V8 XJ Series/XK

413-S484

TECHNICAL BULLETIN

Instrument Pack Assembly – CAN Failure – Service Action S484

ILLUSTRATION 4

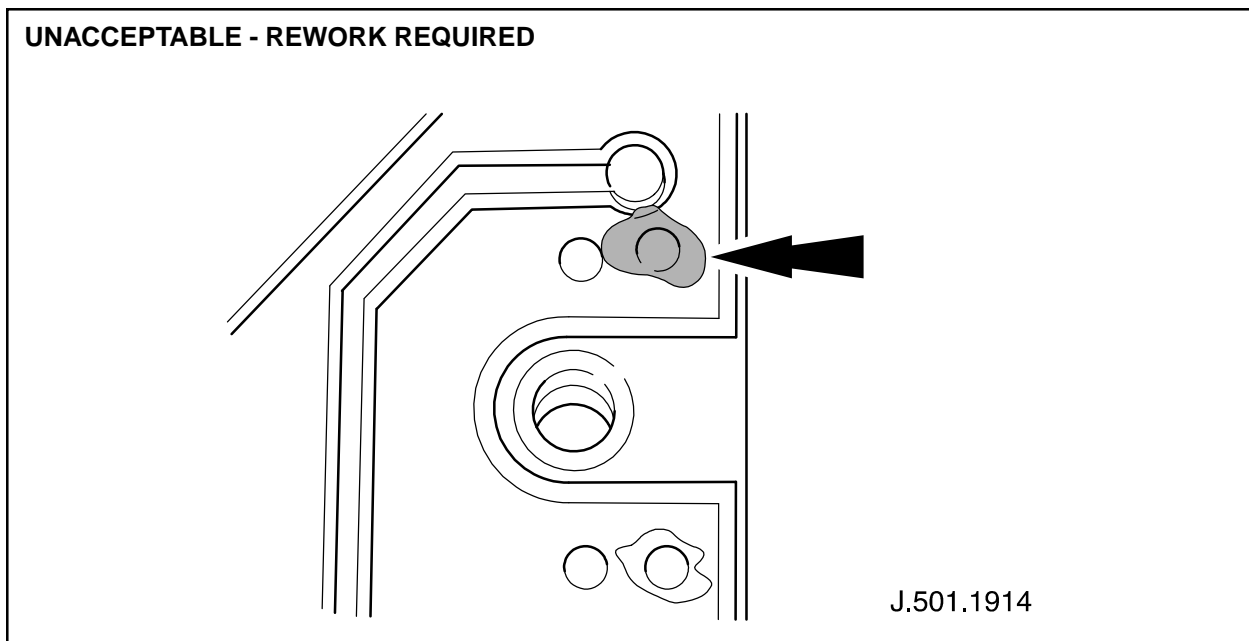
Illustration 4 shows an unacceptable case. This circuit board requires rework

If rework of the solder area is required (Illustration 4) proceed to step 11.

11. Using a sharp craft knife, raise and fold back any solder that has spread beyond the borderline area, as shown in illustration 5
12. Using a sharp craft knife, cut off the raised solder segments. See illustration 5.
13. Using a continuity meter, check there are no shorts between test point 1 and the two adjacent solder points 2 and 3 as shown in Illustration 5.

ILLUSTRATION 5

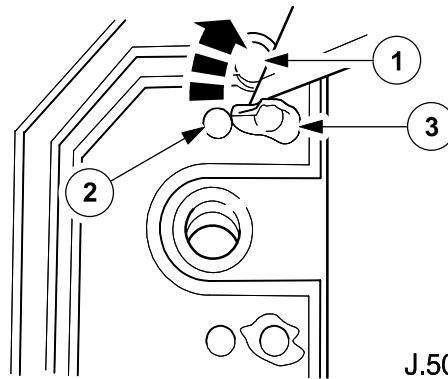
⚠ Caution: Do not use the craft knife in a downward cutting action across the board. This will damage the board. Cut at an angle ensuring that only the solder is cut through. Ensure all traces of cut solder are removed and discarded. Do not leave any solder particles. This could cause further contamination to the board. Do not remove solder from other areas of the circuit board, only those identified in this Service Action.

Note: Do not test between points 2 and 3 since these are ground points.

⚠ Caution: During the test operation in step 13, if a short is present, repeat solder removal operation.

ILLUSTRATION 6

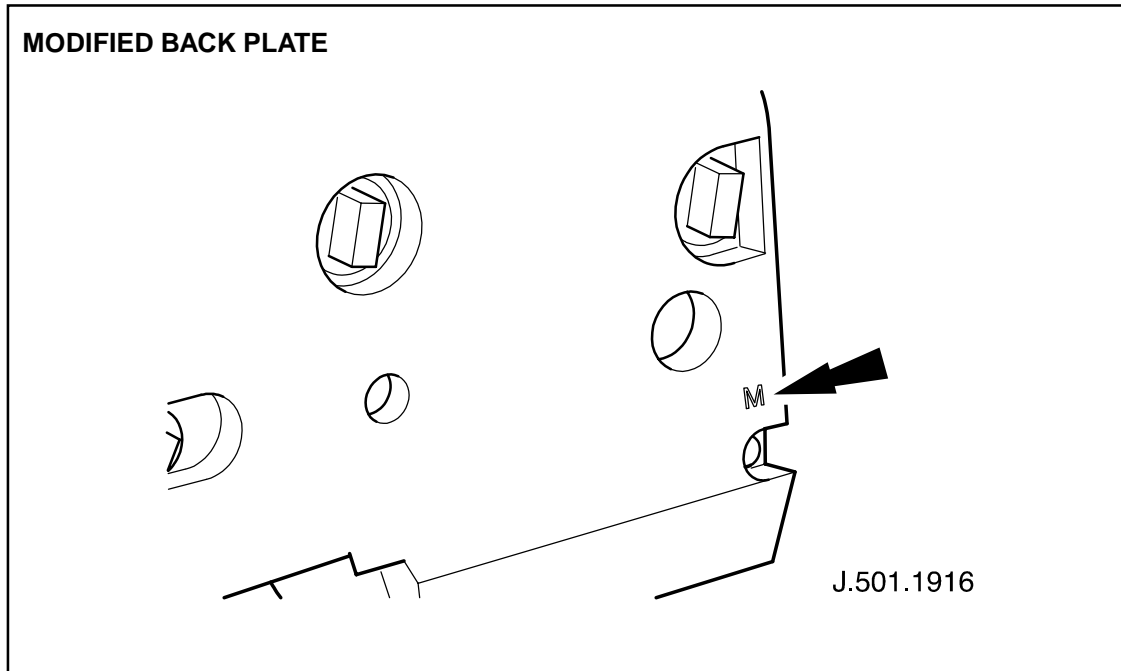
Note: The supplied modified back plate is identified by an “M” mark on the outer face, this will inform future workshops that the back plate has been replaced (Illustration 6).

14. Position and seat the new supplied module back plate. (Modified back plate has relieved screw boss).

15. Fit and tighten back plate securing screws. (Torque 0.5 - 0.8 Newton meters)
Suitable torque screwdriver for previous operation ‘Snap On’ QTSP135 or SPX 18 G.681 & T20 Torx bit.
